Number	Description
1	Added Notice To Bidders Nos. 1963, 2927, 2928 w/attachments, and 2929; Revised Table of Contents; Revised Wage Rates; Revised Bid Items; Amendment EBSx Download Required.

**MISSISSIPPI DEPARTMENT OF TRANSPORTATION
TABLE OF CONTENTS**

PROJECT: NH-0022-04(065)/108147301 - Union

SECTION 904 - NOTICE TO BIDDERS NO. 2928

GUARDRAIL:
"W" BEAM
(STEEL POSTS)

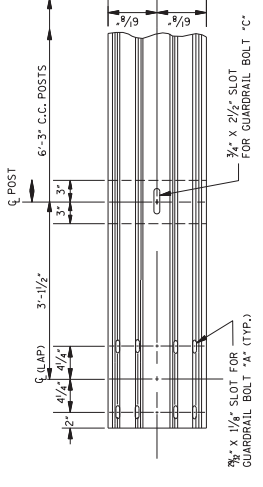
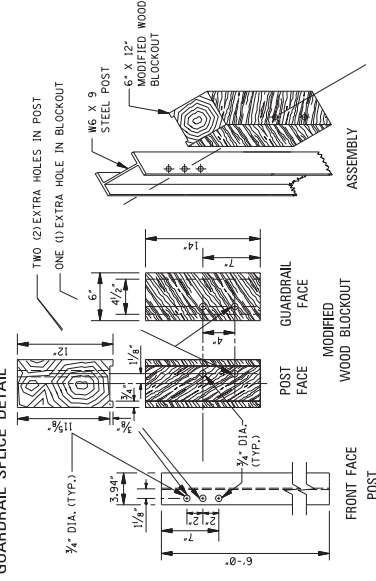
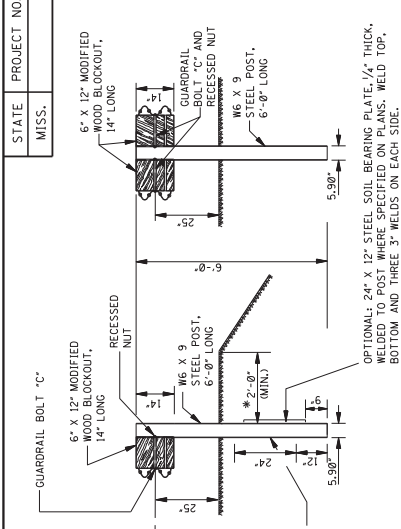
Bidders are hereby advised that the Summary of Quantities sheets in the Plans do not include the following pay items:

1. 202-B150, Removal of Guard Rail Including Post, Blockouts & Hardware
2. 202-B152, Removal of Guard Rail Terminal End Section
3. 606-B001, Guard Rail, Class A, Type 1
4. 606-D005, Guard Rail, Bridge End Section, Type A
5. 606-D012, Guard Rail, Bridge End Section, Type D Modified
6. 606-E005, Guard Rail, Terminal End Section, Flared.

These items are to be used to replace existing guard rail in accordance with the attached standards at the three bridges within the project limits and the guard rail at the box culvert between County Road 107 and County Road 96. The estimated quantities are shown in the table below. The quantities on the bid items are correct. Any work required to remove and replace guard rail that is not covered by pay items in the bid items including any connections or appurtenances shall be absorbed in other items bid.

Pay Item No.	Description	Original Quantity	Revised Quantity
202-B150	Removal of Guard Rail Including Post, Blockouts & Hardware	0 LF	1,818 LF
202-B152	Removal of Guard Rail Terminal End Section	0 EA	16 EA
606-B001	Guard Rail, Class A, Type 1	0 LF	1,600 LF
606-D005	Guard Rail, Bridge End Section, Type A	0 EA	4 EA
606-D012	Guard Rail, Bridge End Section, Type D Modified	0 LF	8 EA
606-E005	Guard Rail, Terminal End Section, Flared	0 LF	16 EA
